Stage 1 Road Safety Audit

Uisce Éireann

December 2025

MORTARSTOWN WASTEWATER TREATMENT PLANT UPGRADE - RSA 1

Figure 2-2 – Poorly secured temporary traffic cones north and south of the WwTP entrance.

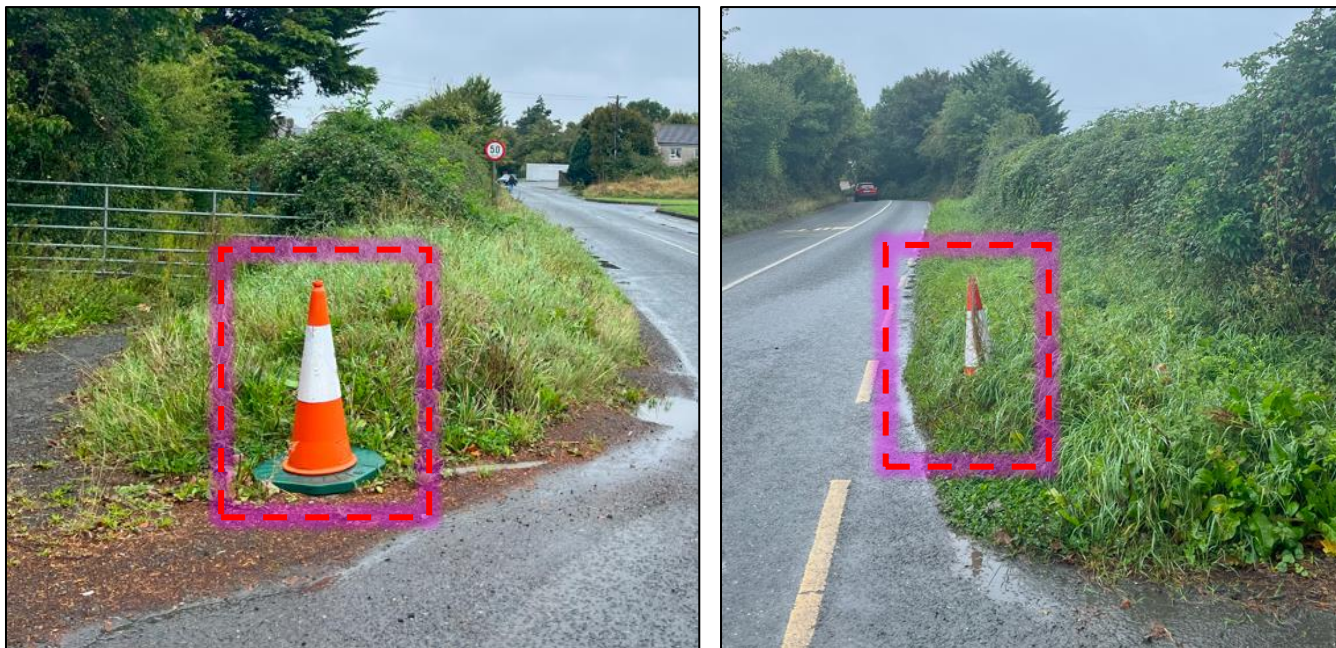
Location: North and South of the WwTP entrance.

The temporary traffic cones placed at the north and south of the WwTP entrance are inadequately secured. During heavy storms the temporary traffic cones may be displaced onto the roadway and lead to unexpected vehicular movements as road users swerve or suddenly brake to avoid the traffic cones. This could result in rear-end shunt type collisions or head-on collisions.

The temporary traffic cones should be removed and consultation undertaken with the WwTP to consider a permanent bollard installation, if the temporary cones were to highlight the entrance.

To be completed by the Designer				To be completed by the Audit Team
Paragraph No. in Safety Audit Report	Problem accepted (yes/no)	Recommended measure accepted (yes/no)	Alternative measures or comments	Alternative Measures accepted by Auditors (yes/no)
2.1	Yes	Yes	To be actioned prior to construction stage commencement.	
2.2	Yes	Yes	To be actioned prior to construction stage commencement.
